**WHEELING PLAN COMMISSION
THURSDAY, JANUARY 24, 2019 6:30 P.M.**

REQUEST FOR PLAN COMMISSION ACTION
STAFF PROJECT REVIEW

RE: **Docket No. SCBA 18-52**
Destaco
1444 S. Wolf Road
Appearance Approval of Freestanding Signs

RE: **Wolf Road Industrial – Panattoni Development**
1020, 1022, 1026, 1027, and 1030 Carol Avenue; 10321 Dean
Avenue; 37 Kerry Lane; and 1032 S. Wolf Road
Docket No. 2019-1
Rezoning from the R-1A Single-Family Residential and I-1
Light Industrial to I-2 Limited Industrial District;

Landscaping Plan - Monument Sign -

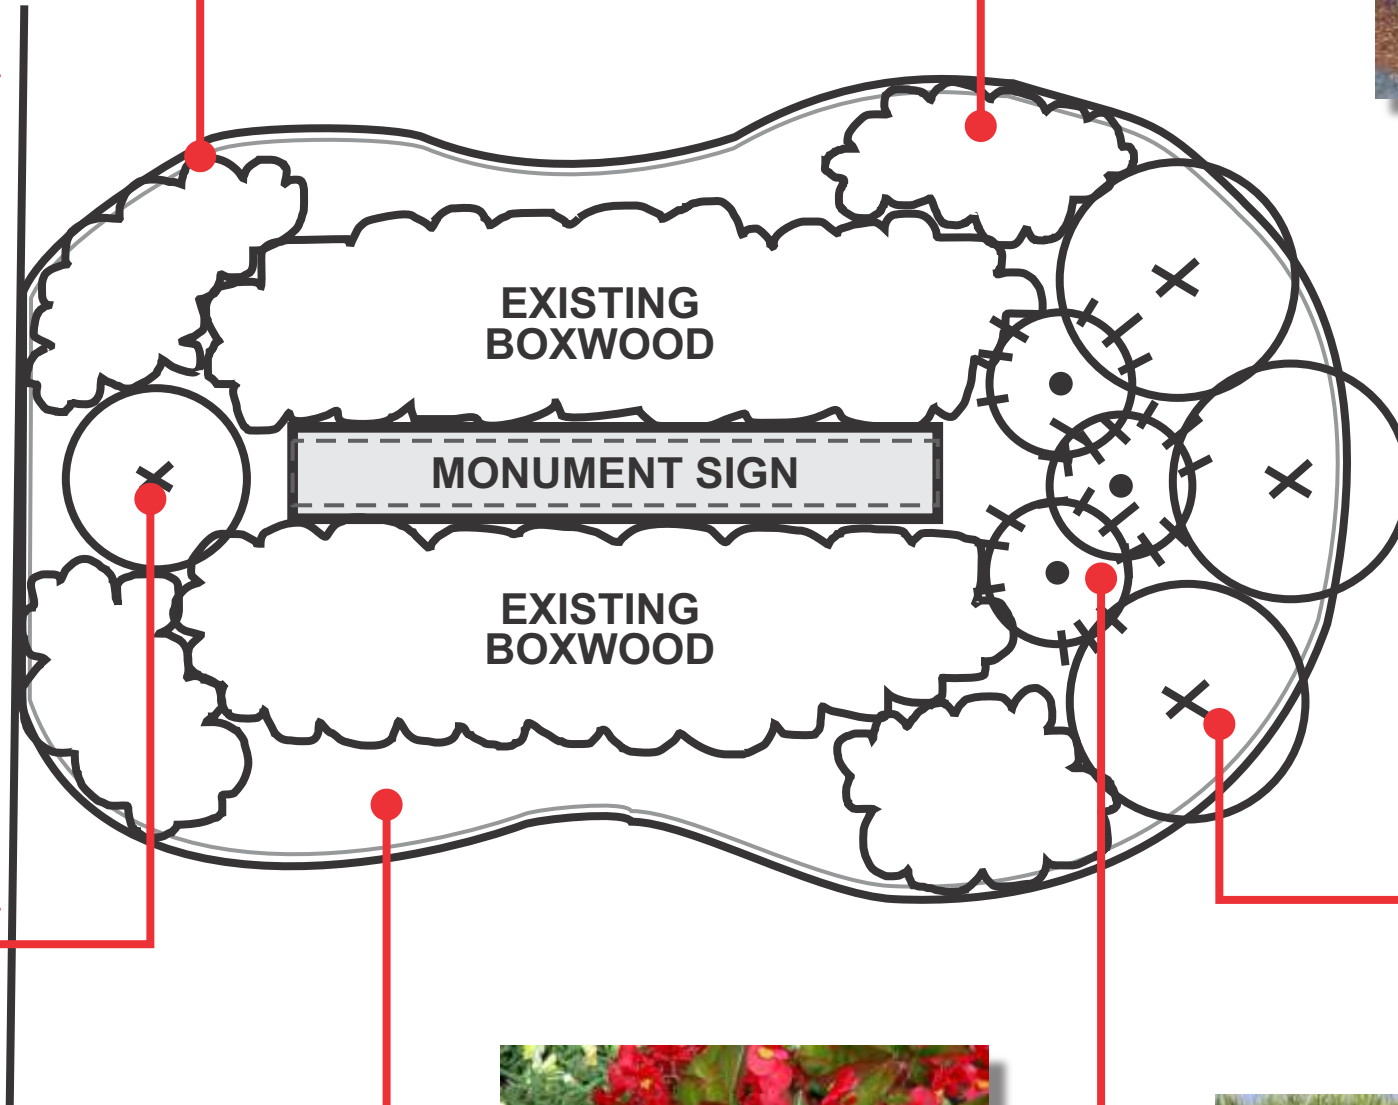
Landscaping: A landscape plan is provided for the business identification sign. The area of the landscaping is approximately 166 sq. ft., which is over twice the size required by the Sign Code. The proposed landscape plans meet the species mix requirements of the Sign Code. It includes evergreens/winter interest (Green Mountain existing boxwood shrubs), deciduous shrubs (Crimson Pygmy Barberry, Gro Lo Sumac), decorative grass (Karl Foerster Grass), and perennial flowers (Stella D'Oro Daylily, May Night Salvia).

PC 18-19 Received 1/17/2019

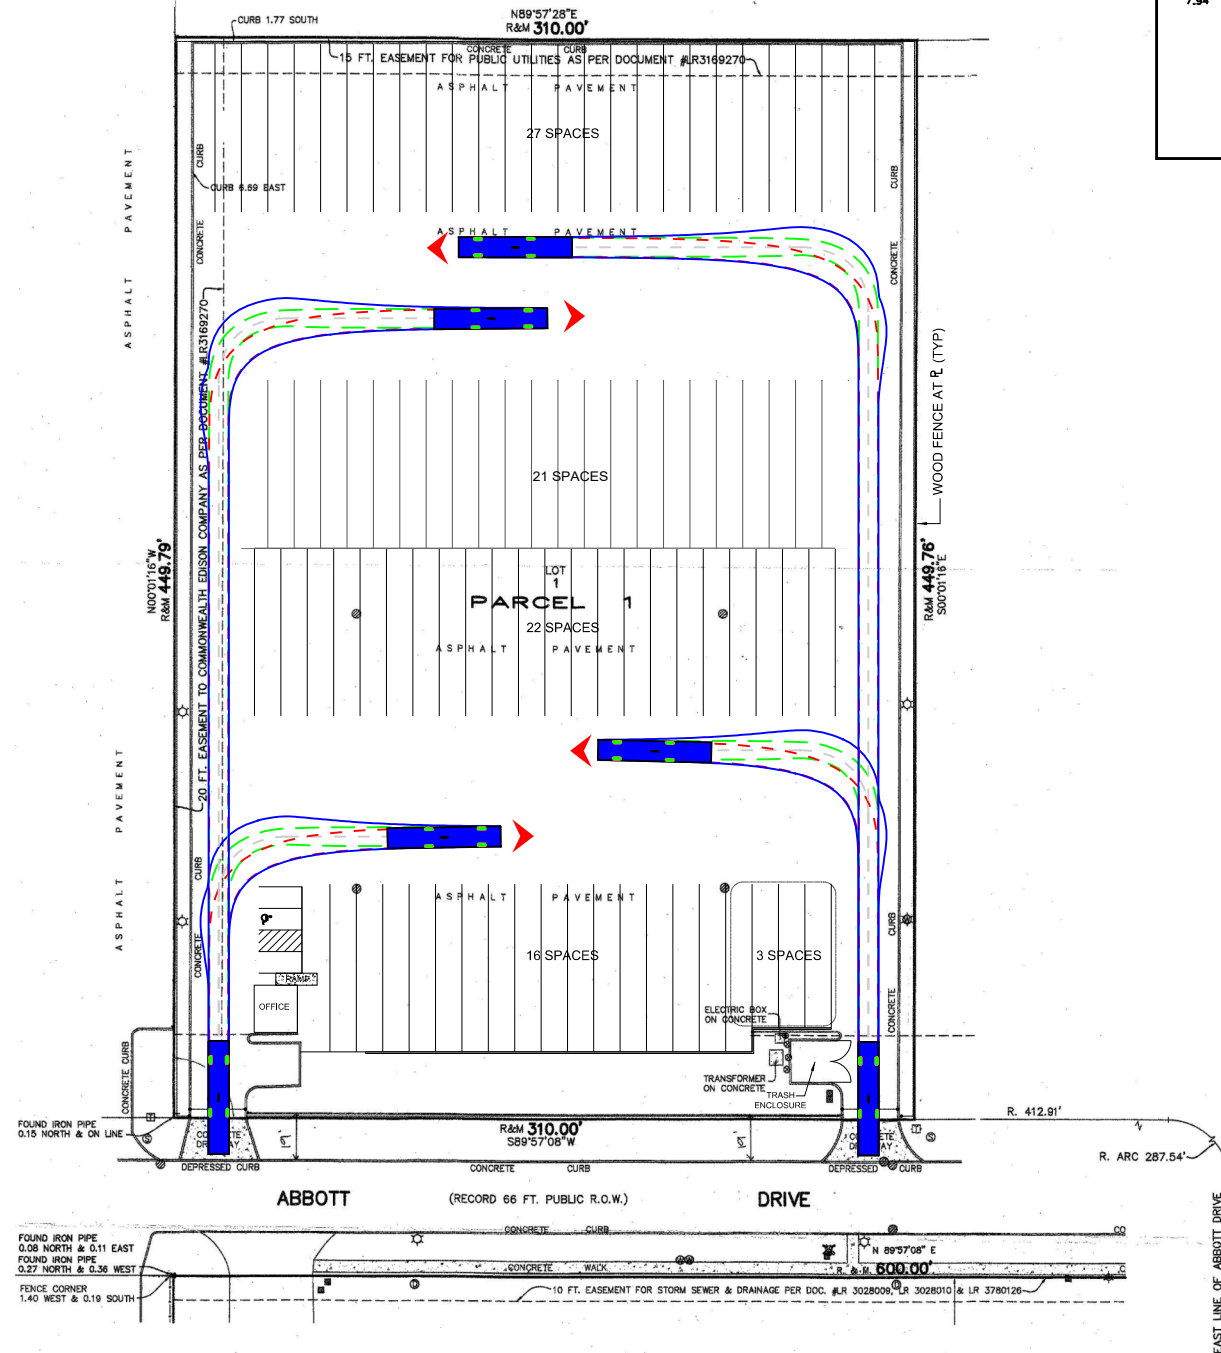
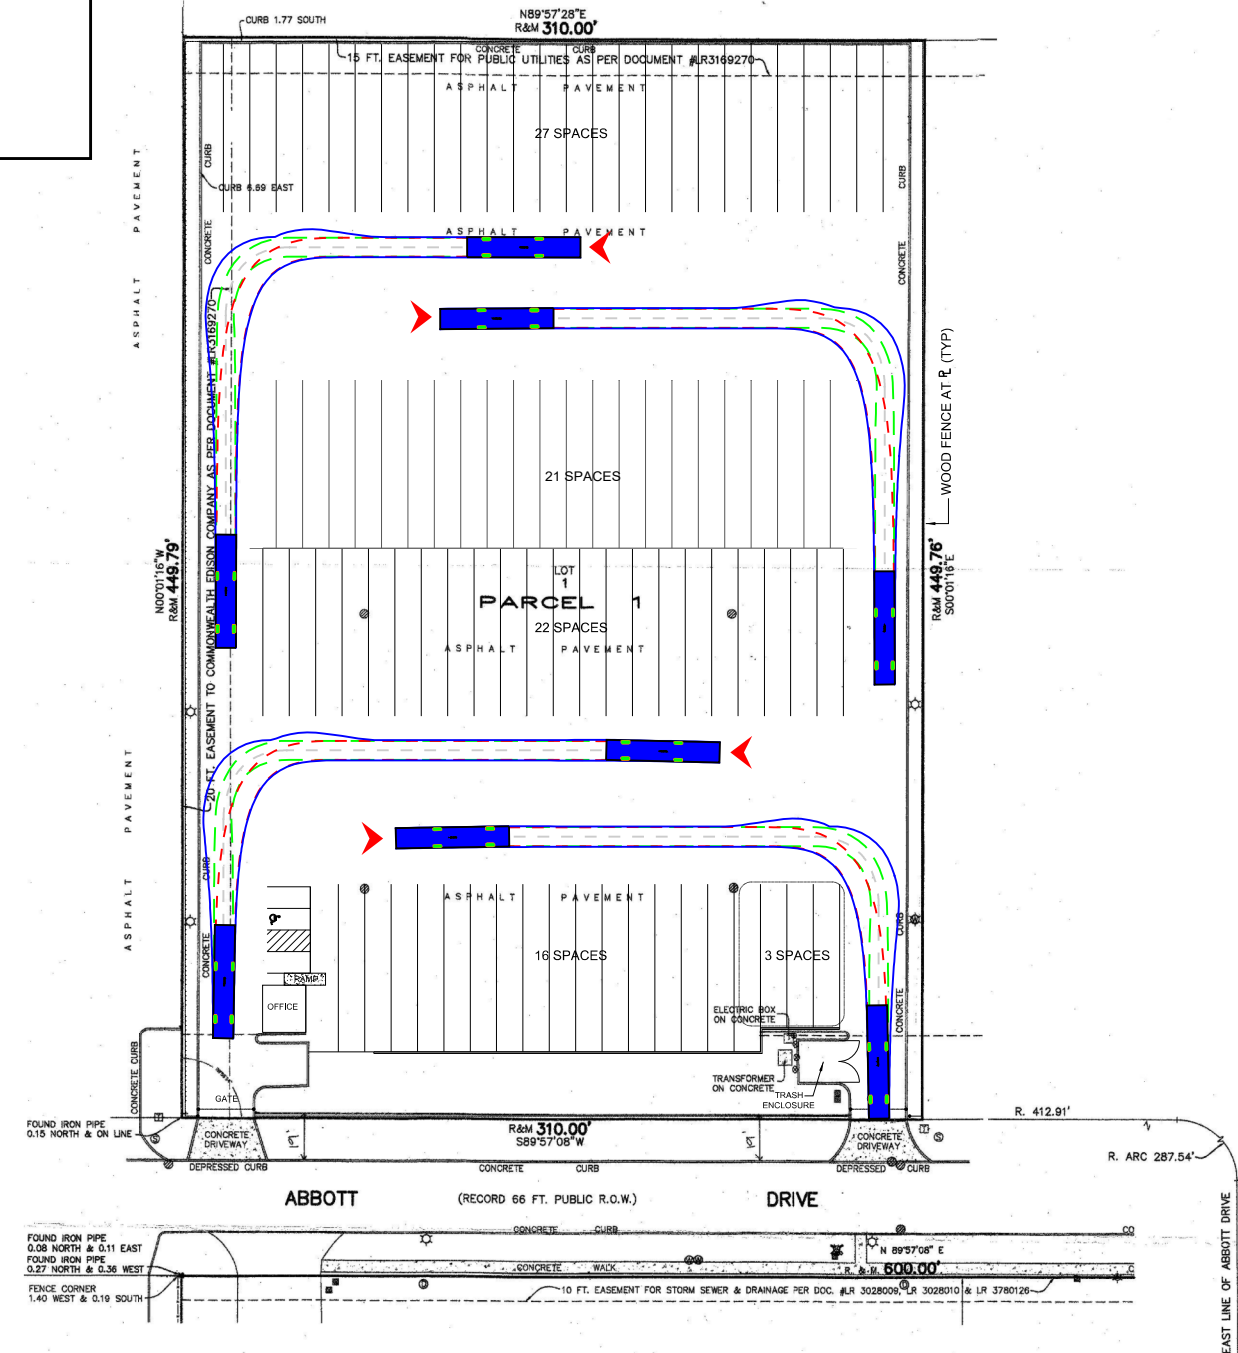
Upon request by staff, the petitioner has provided a fire truck auto turn exhibit for the site based on the reconfiguration of the parking stalls. As demonstrated, a fire response truck can maneuver through the site uninterrupted and there are no conflicts demonstrated.

Fire Department Review: The Fire Department has reviewed the site plan and has indicated the auto turn exhibit sufficiently demonstrates the revised parking layout provides adequate emergency vehicle maneuvering, and further notes that the petitioner's vehicles may require additional movements to navigate the site.

1. The minor change to the site plan shall permit outdoor parking of trucks and contractor's vehicles not to exceed 89 parking stalls (86 in winter due to snow storage), and specifically excludes outdoor material storage and daily/hourly parking.

SITE PLAN

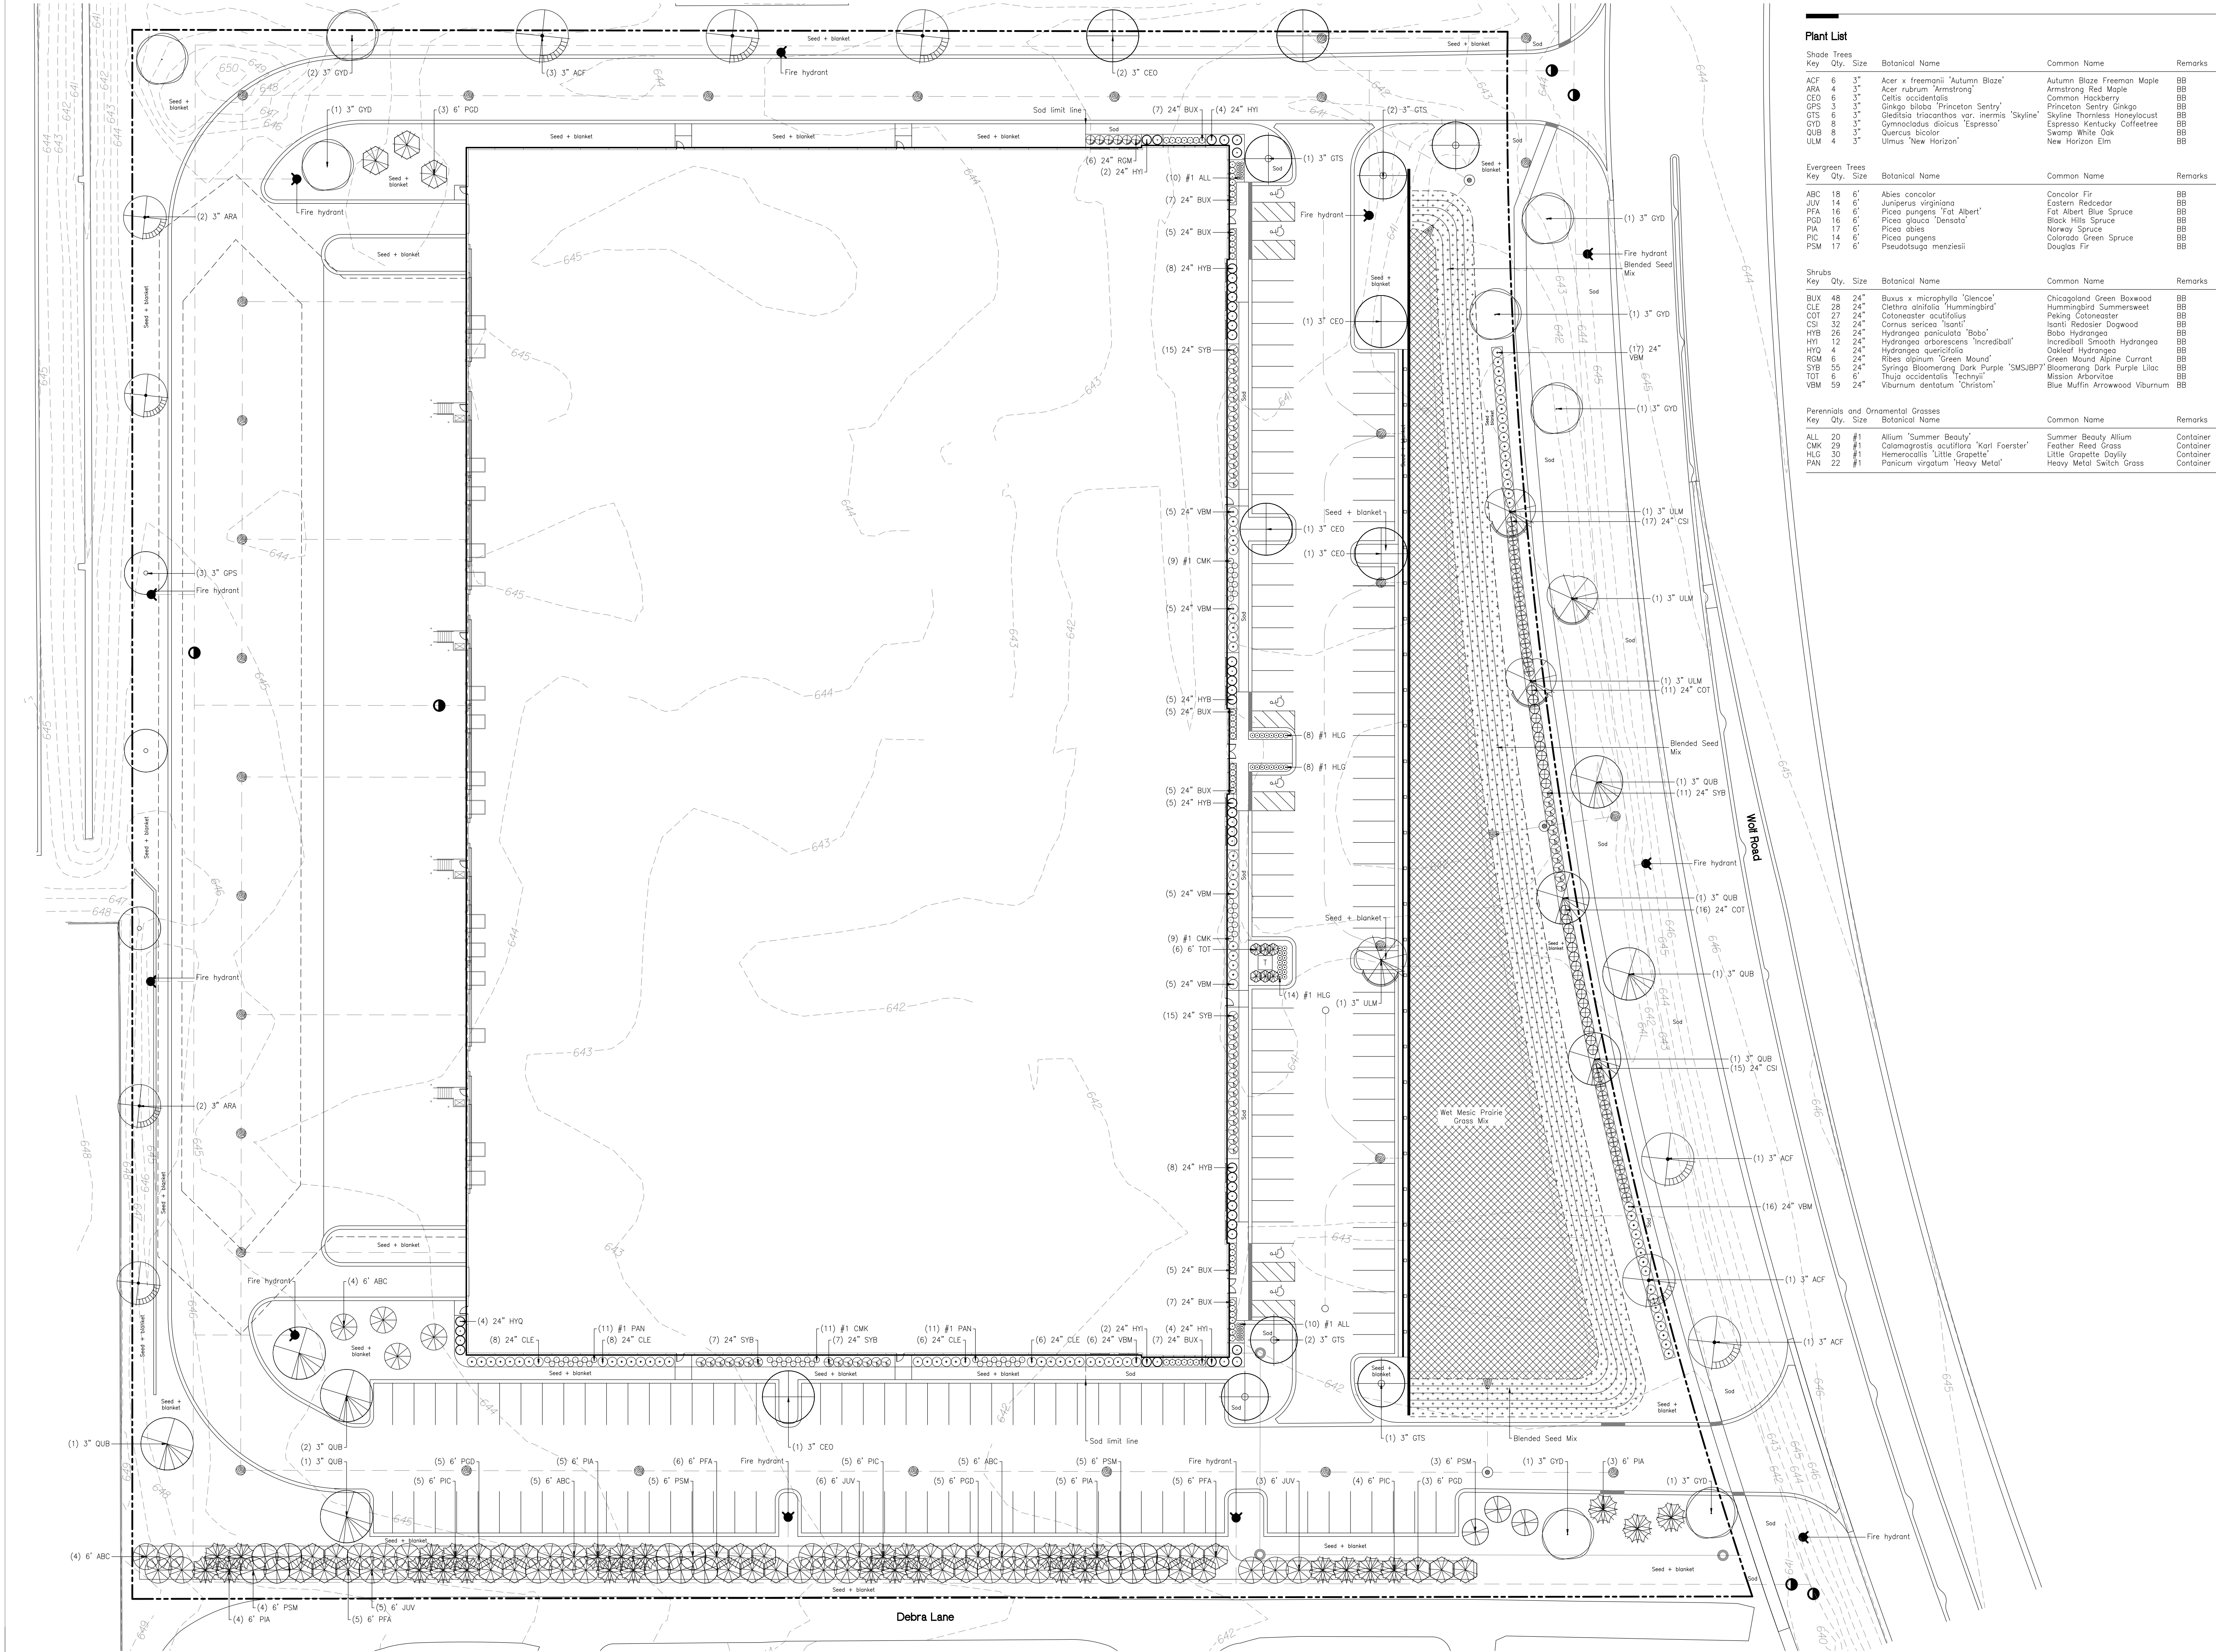
Floor Plan: As the proposed industrial warehouse is speculative and is not being constructed for a specific tenant/business, a floor plan has not been prepared. The site plan indicates the building could accommodate up to three individual tenants, with offices located on the east side of the building, with the truck loading docks in the rear of the building (west side), which is typical for industrial warehouse buildings.

Bicycle parking: No bicycle parking is identified on the plans. The petitioner has indicated to staff that bicycle parking will be provided inside the building. Staff has added a condition of approval that a rack for two bicycles/unit or a single communal rack for 6 bicycles shall be added to the floorplan prior to the issuance of a permit for the construction of the building.

Site Lighting: The site lighting includes a single 25-foot high pole-mounted fixture at the southeastern parking row, while all other light fixtures will be building-mounted at a height of 27' to provide the remainder of the site lighting around the building. The light locations are illustrated on the photometric plan. The LED light fixture can be pole-mounted or building-mounted, and is a shielded design.

HVAC/Mechanical Components Screened: A height detail has been provided indicating the tallest rooftop units will be 6'-2". However, there is no further detail if the rooftop units will be screened by a parapet or by screens. The proposed building height is 40', which is the maximum building height permitted in the I-2 District. The Plan Commission can grant exceptions to the height limitations for necessary mechanical appurtenances and their accessory screening as part of an appearance review. It is recommended the Plan Commission verify all mechanical units are adequately screened.

Trash Enclosure: Exterior trash enclosure are not identified on the plans. The petitioner has identified to staff that all trash will be kept internal. Staff has added a condition of approval that trash collection areas shall be indicated on the floorplan prior to the issuance of a permit for the construction of the building.

1. A rack for two bicycles per unit or a single communal rack for 6 bicycles shall be added to the floorplan prior to the issuance of a permit for the construction of the building.

2. The trash collection areas shall be indicated on the floorplan prior to the issuance of a permit for the construction of the building.
3. Irrigation shall be added to the final landscape plans prior to the issuance of a site (engineering) permit.
